## Wiltshire Council Planning Consultation Response

### URBAN DESIGN

**Application No:** 20/03641/OUT

**Proposal:** Outline application for up to 100 dwellings and a care home (Class C2 Use) of up to 64 beds (up to 3,750 sqm), as well as vehicular access from the A363. Matters to be considered: Access in to the site

*Policy H2.2*

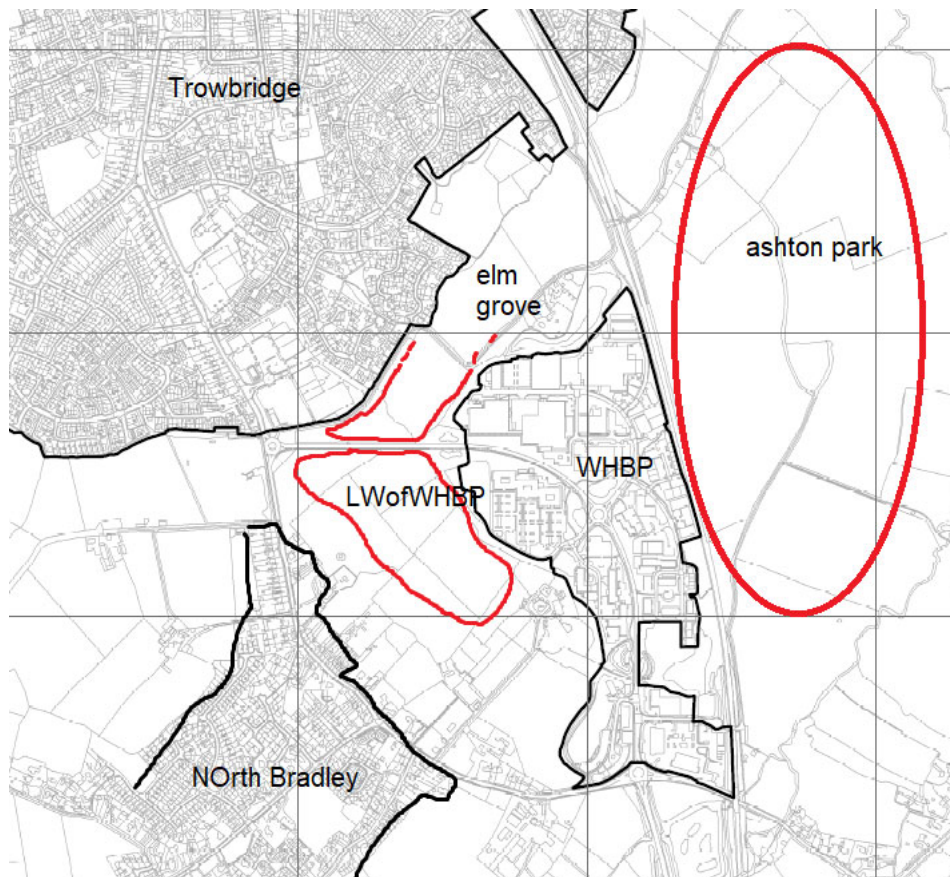
1. This application has been submitted ahead of the approval of a masterplan for the wider area. Thus, an effective urban design assessment cannot be given yet as it is impossible for this outline to accord with a masterplan that is not approved.

Development will take place in accordance with a masterplan approved by the Council as part of the planning application process. The design and layout will take account of all policy requirements, including the timely and coordinated provision of necessary infrastructure to achieve a comprehensive development of the site.

*Separate permissions/allocations*

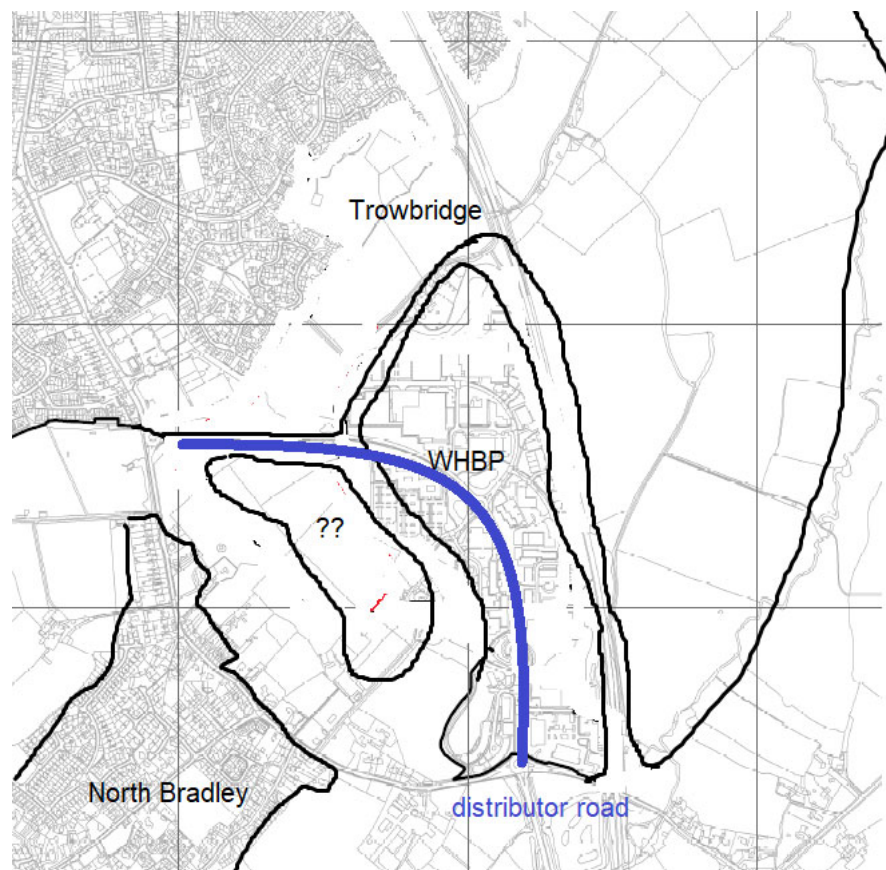
5. Having discussed this briefly with highways officers, it seems there could be constraints on completely changing it to match the character of the A363 as it currently exists within the settlement, but opportunities do exist. **This is an important discussion to have ASAP within the context of the Wider Masterplan noting that that masterplan needs to deals with land outside the applicants red lines:**

*How the development responds to the easement*

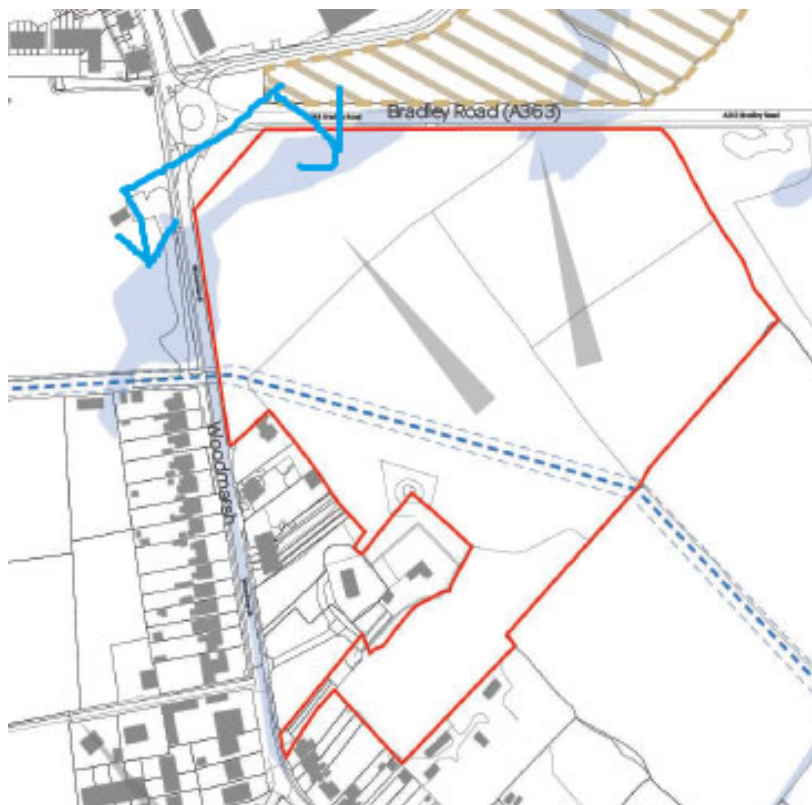
10. To a large extent, the form of the developable area appears to be a direct response to an underground water pipe constraint rather than an obvious regard for the concept of avoiding visual coalescence:

*how a visual 'gap' might be retained.*

11. To properly assess this matter, which is explicitly highlighted as important in Policy H2.2, I recommend an indicative sketch/model from the human level perspective of the site in 3D from the north, to assess how much coalescence there may really be:
